SBK-L-13224
Docket No. 50-443

Seabrook Station

Request for Review and Approval of License Amendment Request (LAR) 11-04, Changes to Technical Specifications for New and Spent Fuel Storage, in Two Parts

Markup of the TS for Spent Fuel Storage Portion of LAR 11-04

Figure 3.9-1
Fuel Assembly Burnup vs. Initial Enrichment
For Spent Fuel Assembly Storage

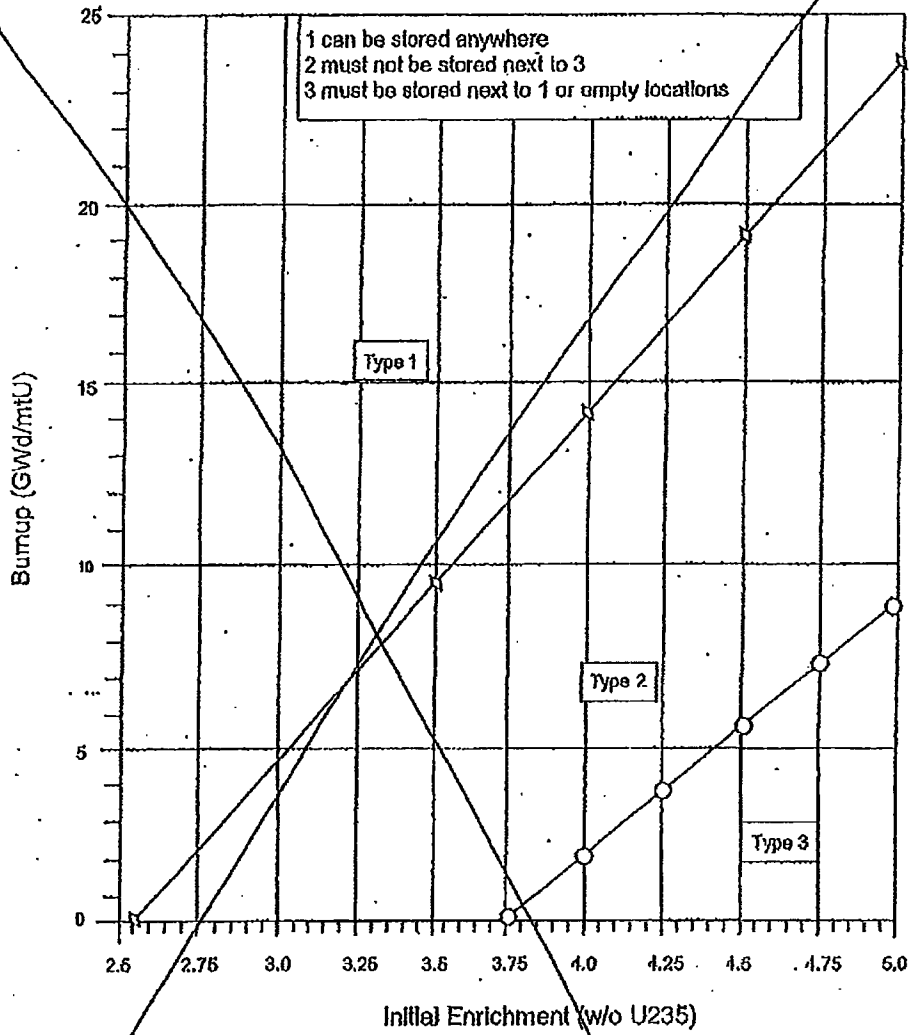
3.9.13 Fuel assemblies stored in the Spent Fuel Pool shall be placed in the spent fuel storage racks according to the criteria shown in Figure 3.9-1 ← Specification 5.6.1.3

- a. With the requirements of the above specification not ^{met} immediately satisfied, suspend all other fuel movement within the Spent Fuel Pool and move the non-complying fuel assemblies to allowable locations in the Spent Fuel Pool in accordance with Figure 3.9-1 ← Specification 5.6.1.3.
- b. The provisions of Specification 3.0.3 are not applicable.

4.9.13.2 After fuel assembly(ies) movement into or within the Spent Fuel Pool, the position of the fuel assembly(ies) that was (were) moved shall be checked and independently verified to be in accordance with the criteria in Figure 3.9-1

DELETE

4.9.13.1 Prior to fuel assembly movement into or within the Spent Fuel Pool, verify by administrative means that the requirements of Specification 5.6.1.3 are satisfied.

5.6.1.3 Fresh or irradiated fuel assemblies shall be stored in the spent fuel pool in compliance with the following:

Figure 5.6-1

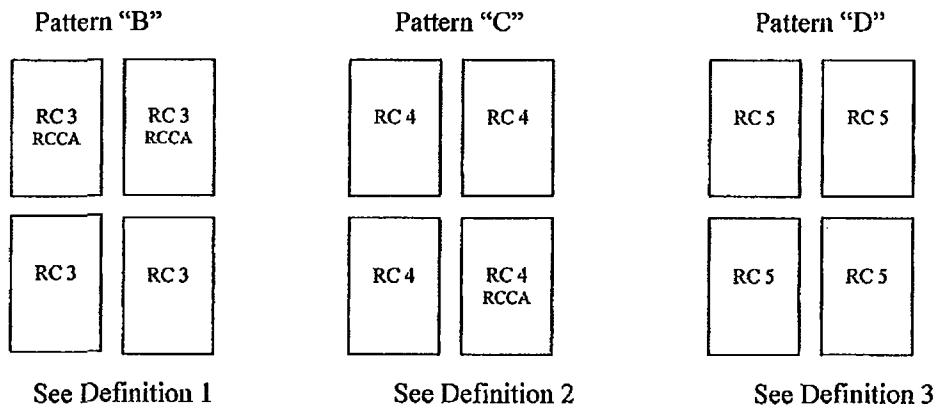
- a. Any 2x2 array of Region 1 storage cells containing fuel shall comply with the storage pattern in Figure 5.6-1 and the requirements of Table 5.6-1. The reactivity ranks of fuel assemblies in the 2x2 array (rank determined using Table 5.6-1) shall be equal to or less than defined for the 2x2 array.

1. Allowable pattern is fuel assemblies that meet Reactivity Class (RC) 1, 2, 3, 4, or 5 checkerboarded with fuel assemblies that meet RC 2, 3, 4, 5. Requirements for all RC are defined in Table 5.6-1. Diagram is for illustration only.

1. There are no interface limitations within Region 1 between rack modules or within racks. Each cell is a part of up to four 2x2 arrays, and each cell must simultaneously meet the requirements of all those arrays of which it is a part.
2. Replacement of any fuel assembly by an empty water hole, non-fuel hardware or fuel rod storage basket is acceptable.
